## HORN DOES NOT WORK

This Service Information bulletin supersedes SI M61 02 16 **dated September 2016**.

What's new:

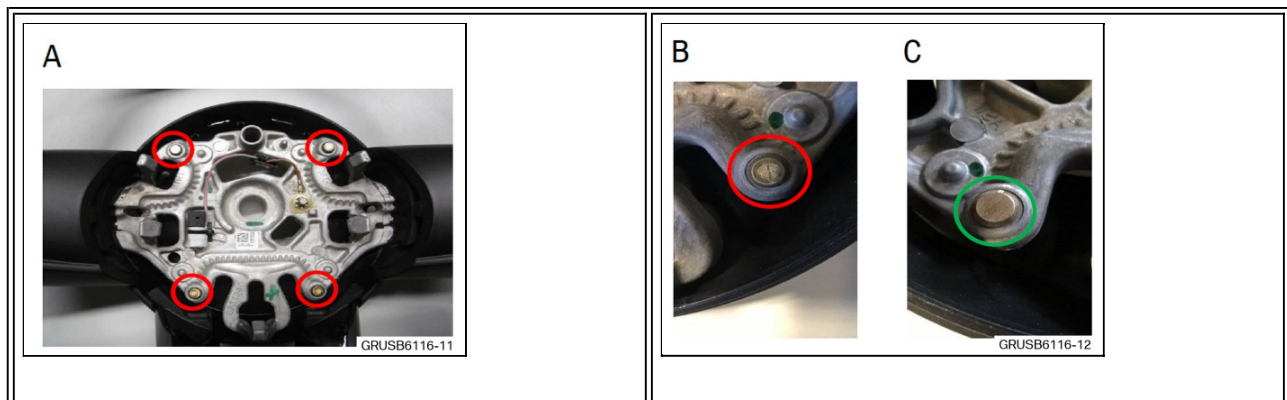
Remove corrosion from switch contact and check routing of wires at steering wheel

1. Remove the air bag unit in accordance with REP 32 34 020 "Remove and refit/replace the air bag unit."
2. Remove corrosion from all four contacts (see Figure A) using sandpaper of 400 grit or higher (see Figure B) until contacts are shiny (see Figure C). It is not necessary to clean the wire for the horn at the airbag unit.

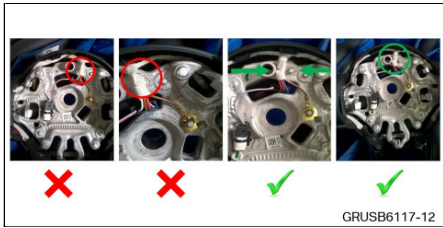
1. For F60 remove the air bag unit in accordance with REP 32 34 020 "Remove and refit/replace the air bag unit." For all other vehicles the air bag is already removed.
2. Check the routing of the connecting line as shown below. If the wires are positioned over the protrusion as highlighted in red, move the wires to the left of the protrusion as shown highlighted in green.
